Division of Reclamation,
Mining and Safety

April 15, 2016

**RE: Objections and Comments to 112c Reclamation Permit Application
Hitch Rack Ranch Quarry; DRMS File No. M-2016-010**

Figure 3 Blockage by Blasting Operations

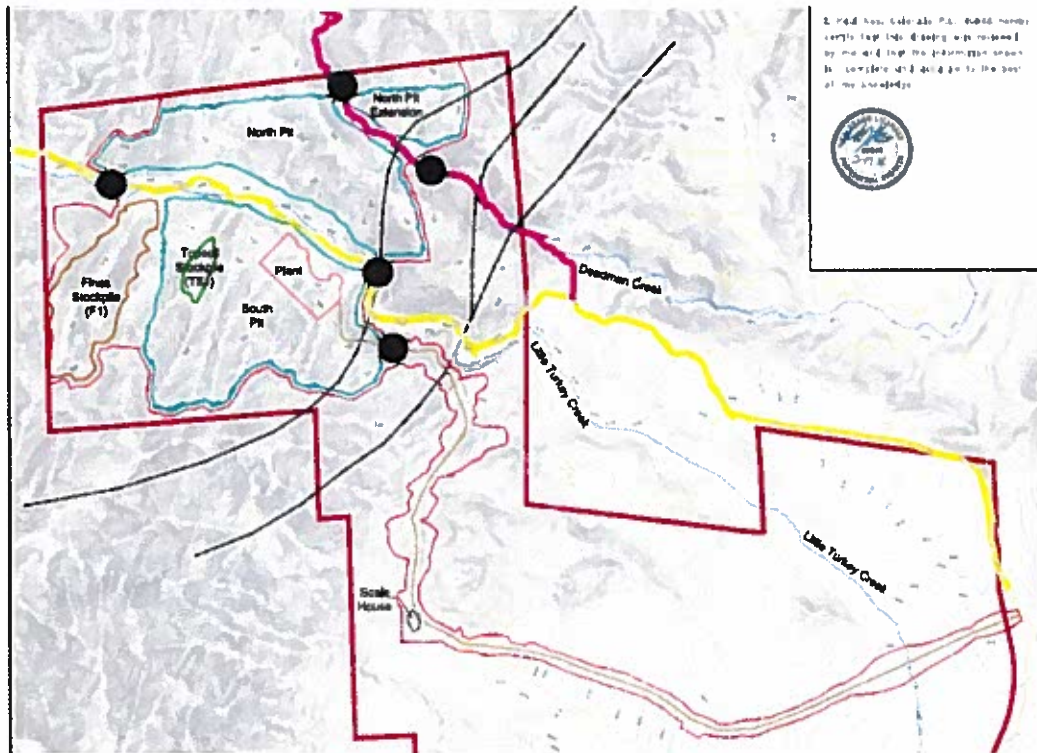
The blasting plan calls for evacuating everyone out of the quarry operations area of the canyon during blasting and using blast guards to prevent access into that area during the actual blasting period. The blasting plan indicates that “Blast guards will be posted at all entrances to the property to make sure no one uses any of the access corridors through the active mining area.” The exact location of these blast guards is not specified in the Transit Mix application, but it is assumed that guards will be posted somewhere along Little Turkey Creek Road to prevent access into the quarry operations area along that road. There will also be a guard on the new quarry road, to prevent access into the quarry from that road. The black circles on Figure 3 shows possible areas where these guards might be posted.

During normal, successful, blasting operations, Transit Mix indicated that the road would be blocked for about 30 minutes. However, in the event of problems or misfires associated with a blast, Transit Mix indicated that the road could be blocked for hours, possibly up to a day, following the blast. While the road is blocked, landowners within Eagles Nest and the former Bauer's Ranch would not be able to use the ingress/egress road to get to or from their properties.

Figure 4 Area of Road in Lower Canyon Prone to Landslides

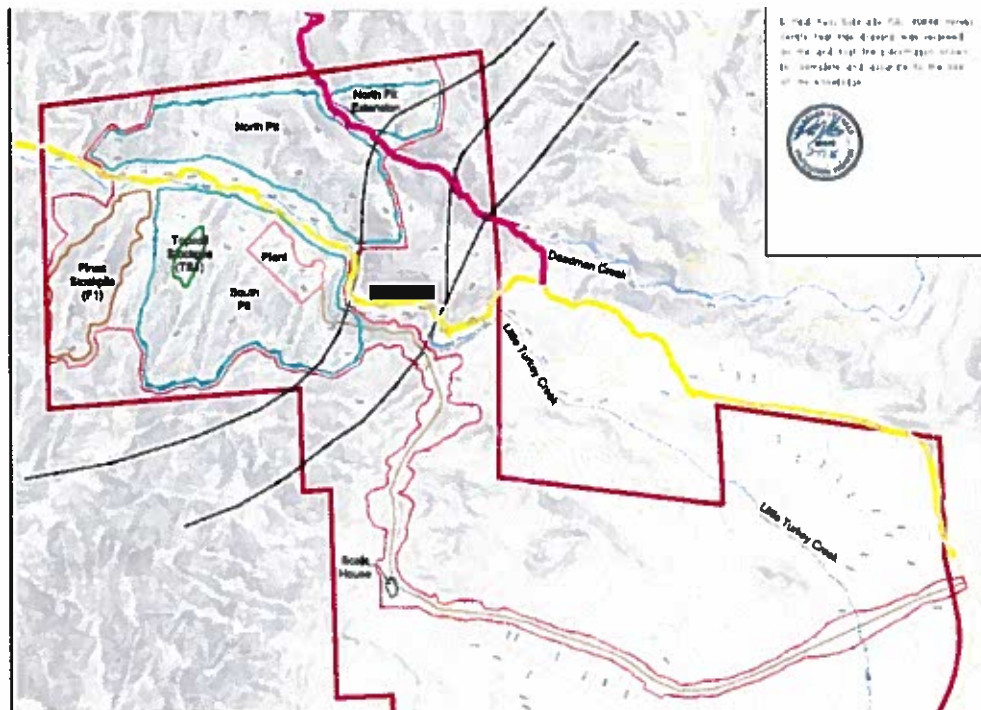
One segment of the ingress/egress road within the lower canyon below the proposed quarry operations area, runs directly beneath a hillside that has very unstable material. Rocks are frequently dislodged from the hillside during heavy rains and tumble down onto the road. In the past, rocks as large as a VW bug slid down that hill, blocking the entire road. That hillside is only a few hundred feet southeast of the proposed North Pit. Blasting operations or other quarry activity may further destabilize that hillside, causing more frequent or more severe landslides on that section of the road. The landslides may injure passing motorists or damage their vehicles and may block that portion of the road. The black area highlighted in Figure 4 highlights this section of the road.

Figure 6 Segment of Road Vulnerable to Landslides within Quarry Pits

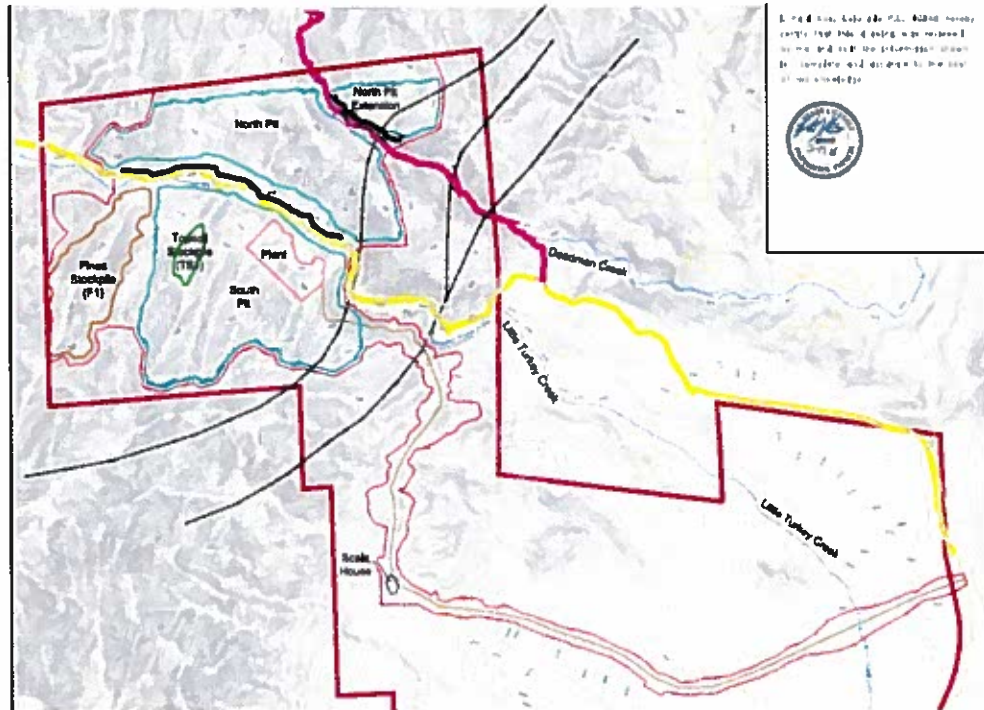
A catastrophic landslide within either the North or South Pits of the quarry may cause quarry material to flow across the segment of Little Turkey Creek road that traverses between the North and South Pits. Such a slide may endanger motorists driving along Little Turkey Creek Road and may block the road. Such landslides might be due to quarry blasting, but might also be due to water seeping into cracks in the remaining rocks within the quarry. Rocks flying from the blasting area may also travel as far as the road. A catastrophic landslide within the North Pit Extension may impact the segment of Little Turkey Creek Road used to access properties in the former Bauer's Ranch.

The black areas highlighted in Figure 6 highlight these sections of Little Turkey Creek Road. The application indicates that the quarry pits will be at least a 100 feet from Little Turkey Creek. However, some segments of Little Turkey Creek Road are a significant distance from the creek, which means that the quarry pits may be less than 100 feet from the road.

Figure 8 Stream Crossings within Upper Hitch Rack Ranch

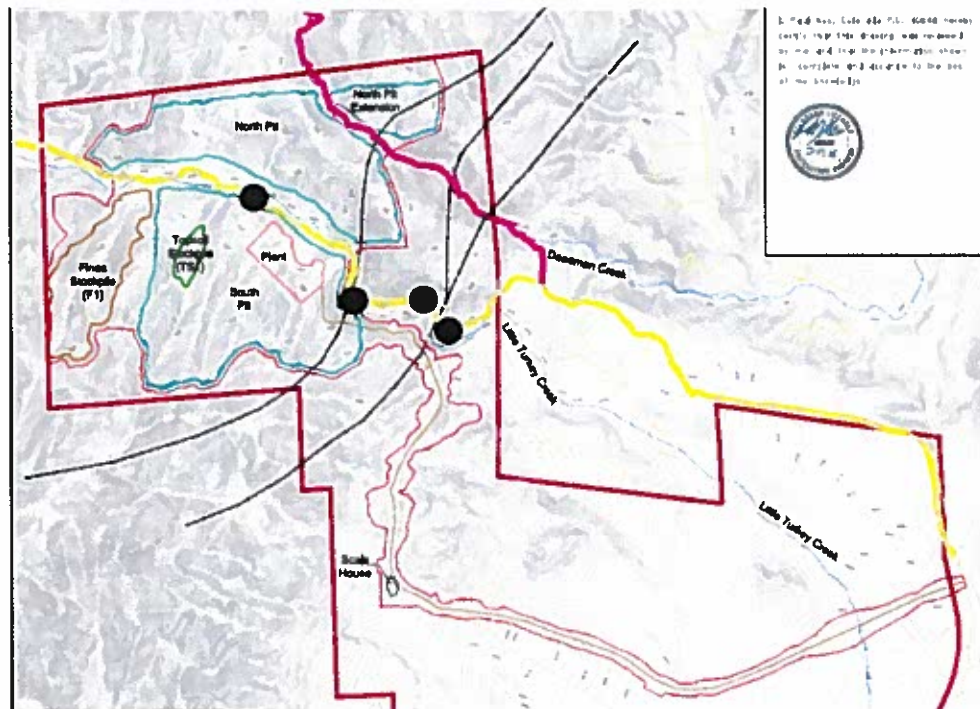
There has been a history of flooding in the Little Turkey Creek canyon, with significant flooding in 1921, 1935, 1965, 1995, 1997, 2013 and 2015, and minor flooding in other years. In 1921 an earthen dam built near the proposed Plant location failed, flooding the lower canyon. Four times in the past 20 years portions of Little Turkey Creek Road within Section 16 have been badly damaged by floods.

There are four locations on Hitch Rack Ranch within Section 16 where the ingress/egress road crosses over Little Turkey Creek, one in the proposed quarry operations area and three within the lower canyon below the proposed quarry operations area. Before Eagles Nest landowners installed culverts on the stream crossings in 2013, the water depth at the stream crossings would run above 2 feet during heavy rains - an unsafe depth to drive through. During the flooding in 2015 after the culverts were installed, the volume of water running in Little Turkey Creek exceeded the capacity of the two 30 inch culvert pipes installed at each stream crossing and caused the creek to overtop the new culverts. The black circles in Figure 8 show the locations of these four crossings.

Figure 9 Sections of Road Prone to Flooding

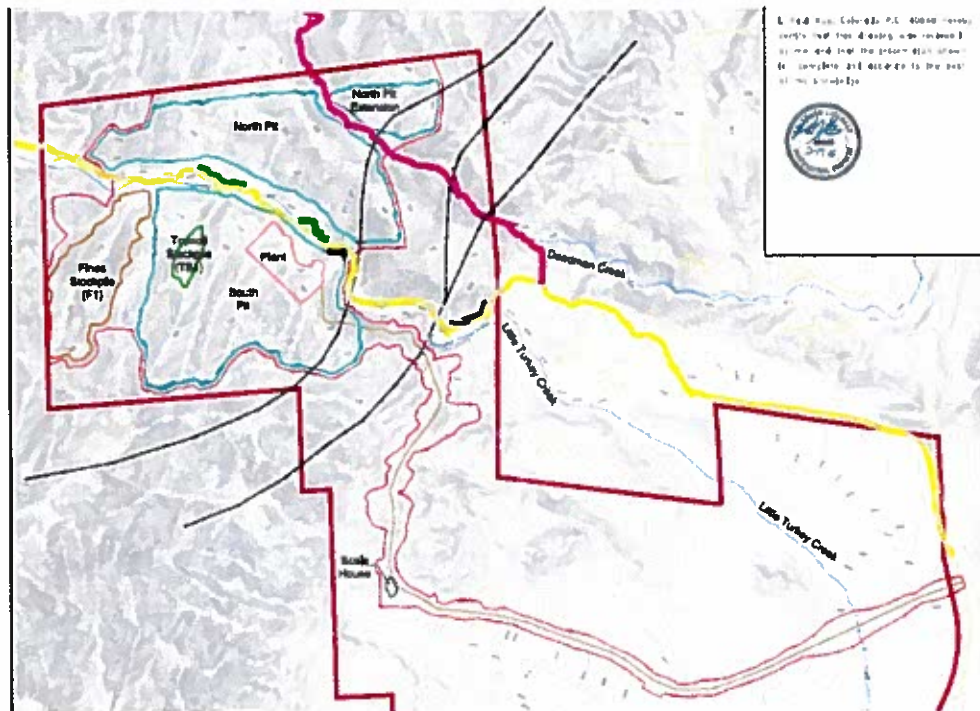
There are also several sections of the road that run beside the stream in the lower canyon, only a few feet above the level of the creek bed (highlighted in black in Figure 9). There have been instances where the creek flooded over its banks and ran down portions of the road. There are other locations where side canyons within the Little Turkey Creek watershed drain across the road and down into the creek (highlighted in green in Figure 9). These

draws are normally dry, but can run during heavy rains. At times, the water flowing down these side draws has turned and run down the road, causing damage to the road.

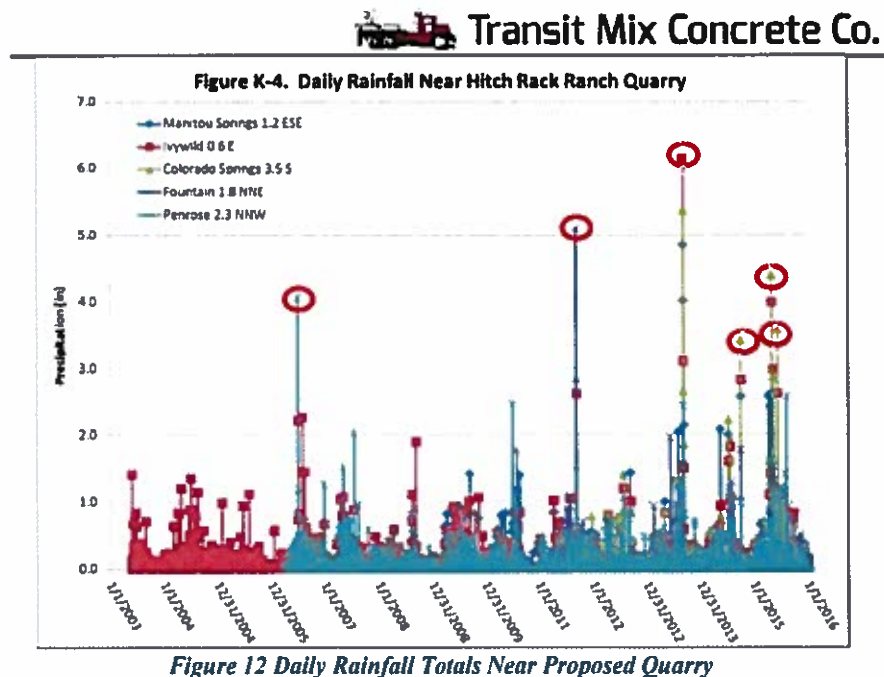
Figure 12, extracted from Exhibit K, shows Daily Rainfalls for various weather stations near the proposed Hitch Rack Ranch Quarry. Note that there are six days in the past 10 years where the rainfall amount exceeded 3 inches (circled in red). This would suggest that the use of 3.03 inches for a 10 year storm is not adequate.

Figure 13 Portion of Little Turkey Creek Road in Lower Canyon

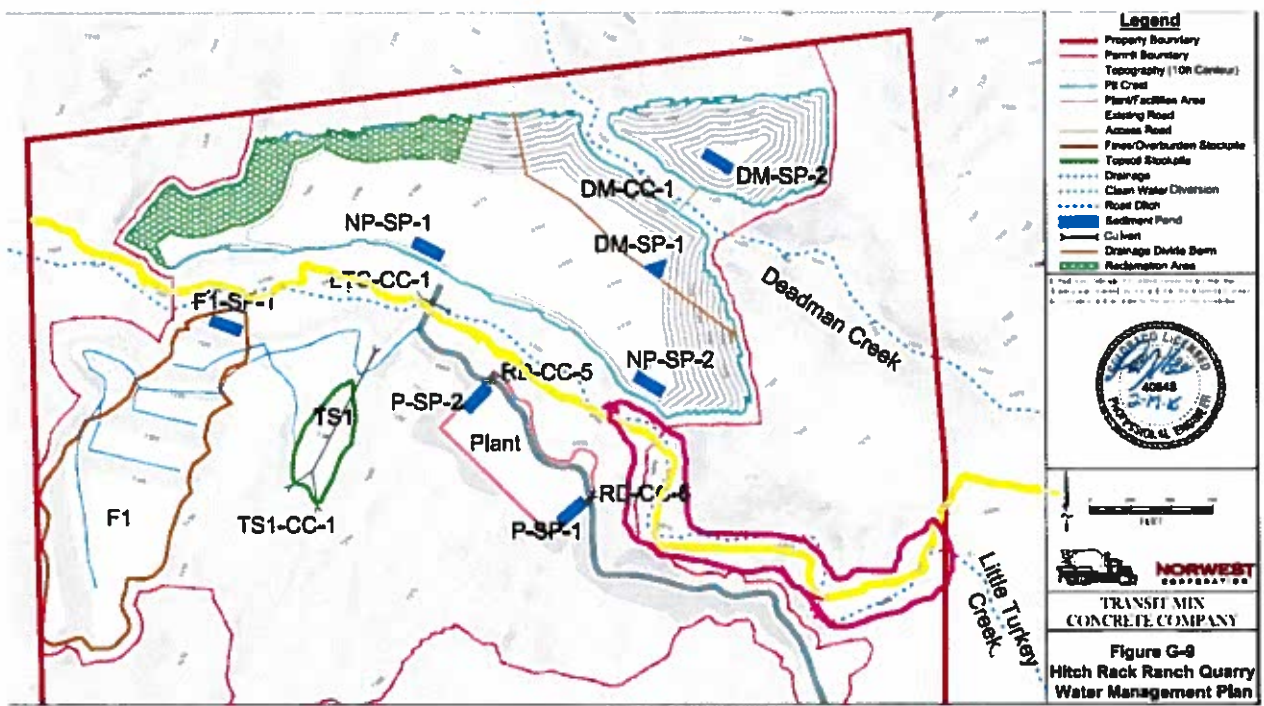
The sediment ponds within the Little Turkey Creek watershed are designed to impound over 82 acre feet water if filled to capacity (over 26 million gallons of water). If these sediment ponds fail during a severe flood event, the large volume of water stored in those ponds, plus top soil, fines and other quarry material may be transported down the canyon during that flood event. This may entirely block the road within the lower canyon (highlighted in fuchsia in Figure 13).

Figure 14 Reclamation Ditches near Little Turkey Creek Road

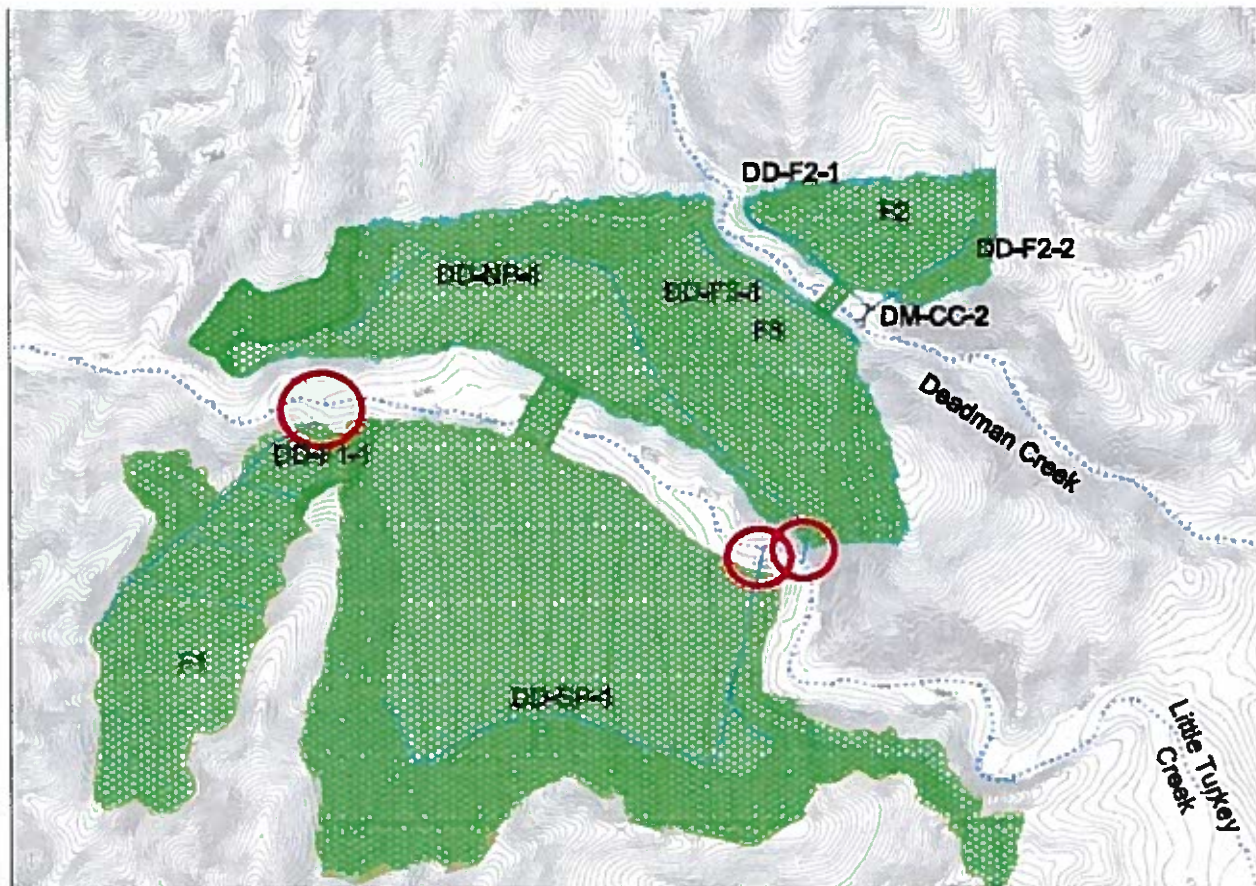
Figure 14 is extracted from Figure G-12 of the Transit Mix application. It shows the Water Management Plan for the Final Reclamation Phase. In this plan, there are several ditches which will be built to drain the reclaimed North Pit, South Pit and Fines storage area into Little Turkey Creek. These ditches are the blue lines drawn on the image. Depending on the exact location of these ditches, water flowing from these ditches may run across Little Turkey Creek Road, blocking the road. The possible locations where these ditches may impact the road are circled in red.

Figure 15 Portion of Little Turkey Creek Road in Section 16

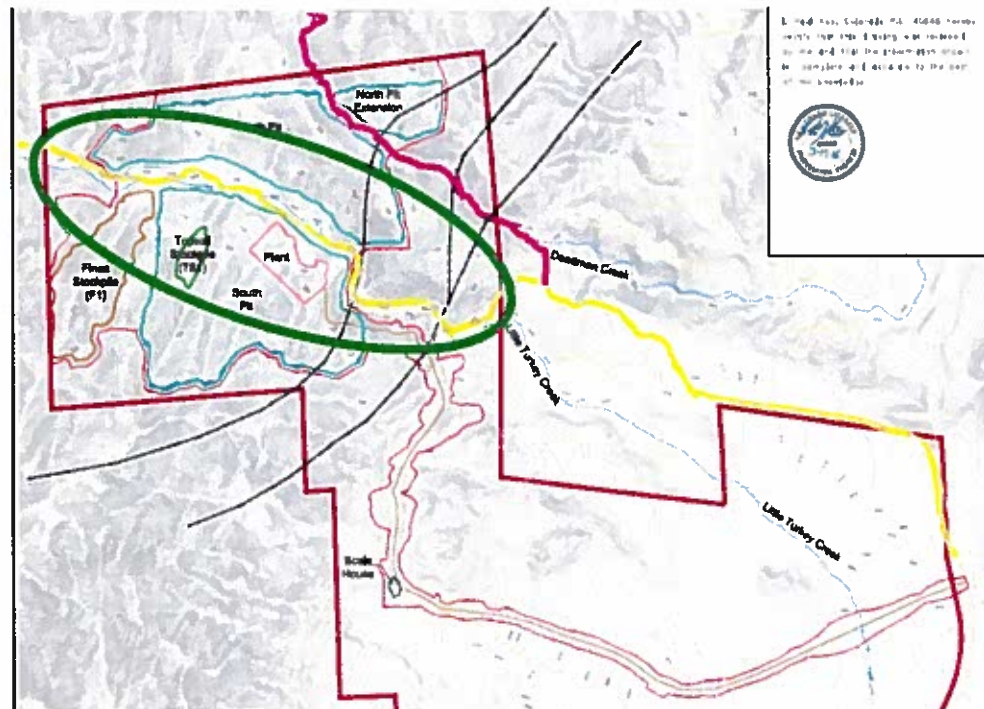
Little Turkey Creek Road is a private road maintained by property owners along the road. For almost 50 years, landowners within Eagles Nest have maintained the portion of the road within the south canyon that runs across Hitch Rack Ranch. Little Turkey Creek road is the yellow line in Figure 15. The green oval highlights the portion of the road that runs across Hitch Rack Ranch land within Section 16.

In the 1990s the Hitch Rack Ranch owner realigned the road between the first gate and the first stream crossing to redirect water from Little Turkey Creek into her irrigation ditch. After the 2013 flood, the ranch gave permission to Eagles Nest landowners to use rocks from the historic dam as fill material to repair a segment of the road that was destroyed by water washing onto the road near that dam. Other than those two instances, Hitch Rack Ranch has never contributed towards the maintenance or repair of the road. As a result, maintenance, repairs and improvements of the road within Section 16 have been a financial burden borne entirely by Eagles Nest landowners. That burden has been particularly significant after major flooding events. Any increased frequency or severity of flooding or landslides damaging the road may increase the cost to repair the road, placing an even greater financial burden on Eagles Nest landowners.

Figure 16 Area at Mouth of Little Turkey Creek Canyon Vulnerable to Flooding

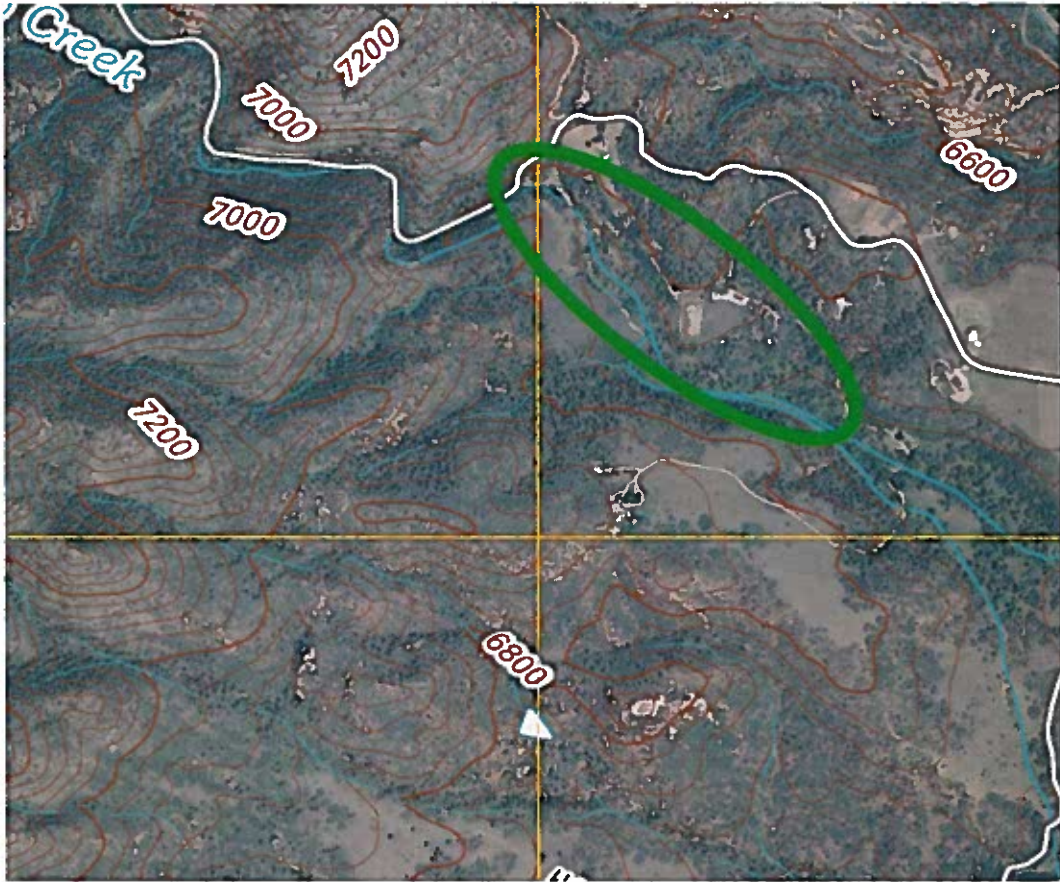
Catastrophic flood events, which may be more frequent or more severe due to removal of vegetation within the Little Turkey Creek watershed, may damage property and houses located outside the canyon along Little Turkey Creek. Figure 16 shows a small segment of the 2011 Mount Big Chief Colorado Map. The blue line is Little Turkey Creek. The white line is Little Turkey Creek Road. The green oval highlights properties located at the mouth of the canyon

vulnerable to flood events within the Little Turkey Creek watershed. While this property damage will not directly impact Eagles Nest owners, it will certainly impact our neighbors who live further down our road.

Figure 17 Nearby Water Wells

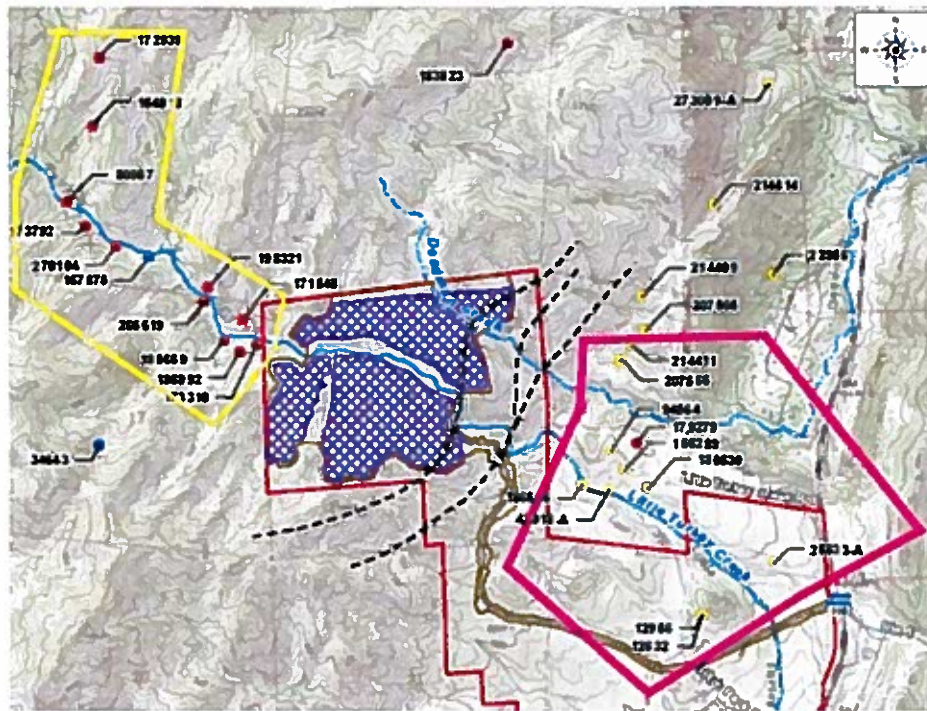
Properties along Little Turkey Creek Road rely on private residential wells. As shown in Exhibit G of the Application, the Transit Mix application identified and located a number of wells within a short distance of the proposed quarry operations area. Figure 17 is extracted from Exhibit G (FIGURE 2 Transit Mix Hitch Rack Ranch Surface Water Feature Location Map).

At least one of the wells within Eagles Nest was omitted from the application information. It happens to be one of the wells closest to the northwest quarry operations boundary. This raised the question of how many additional affected wells were not included in the research and analysis.
